ISO/IEC 7776

AMENDMENT 1
1996-11-15

Information technology — Telecommunications and information exchange between systems — High-level data link control procedures — Description of the X.25 LAPB-compatible DTE data link procedures

AMENDMENT 1: Modulo 32 768 and multi-selective reject option

Table 10 – Control and Information field encoding of SREJ frame - Extended (modulo 128) operation

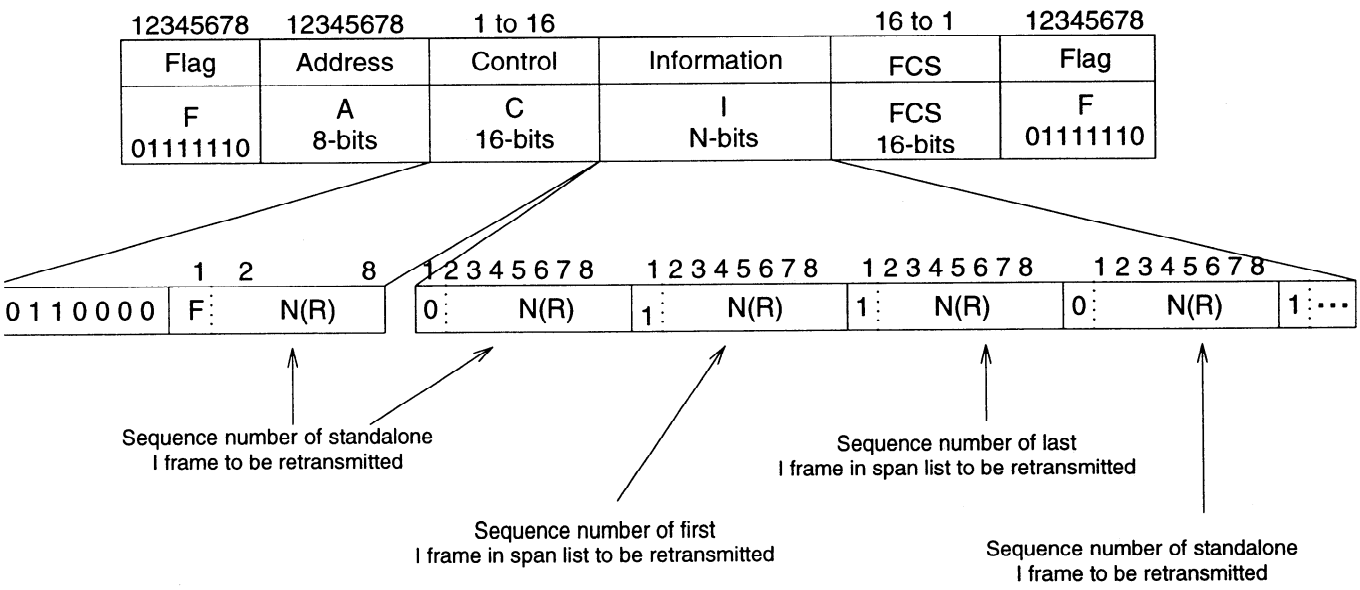
Insert a new subclause 4.3.5 as follows and renumber all subclauses that follow:

4.3.5 Selective reject (SREJ) response

The selective reject, SREJ, frame shall be used by a DTE to request retransmission of one or more (not necessarily contiguous) I frames. The N(R) field of the control field of the SREJ frame shall contain the sequence number of the earliest I frame to be retransmitted and the information field shall contain the sequence numbers of additional I frame(s), if any, in need of retransmission. (The DTE shall create a list of sequence numbers N(X), N(X+1), N(X+2), N(Y), N(Z+3), N(Z+4), ... , N(S)-1, where N(X) is greater than or equal to V(R) and none of the I frames N(X) to N(S-1) have been received. The N(R) field of the SREJ frame shall be set to N(X) and the information field set to the list N(X)+1, ..., N(S)-1.)

For extended (modulo 128) operation, the information field shall be encoded such that there is an octet for each standalone I frame in need of retransmission, and a two-octet span list for each sequence of two or more contiguously numbered I frames in need of retransmission, as depicted in table 10. In the case of standalone I frames, the sequence number of each designated I frame shall occupy bit positions 2-8 of an octet, with bit position 1 set to zero, as depicted in table 10. In the case of span lists, the sequence number of the first designated I frame in need of retransmission is encoded in the first octet (of the two octet field for span lists) and the second octet contains the sequence number of the last designated I frame in the sequence in need of retransmission. Sequence numbers in both octets are encoded in bits 2-8 with the bit position 1 in both octets set to 1 as depicted in table 10.
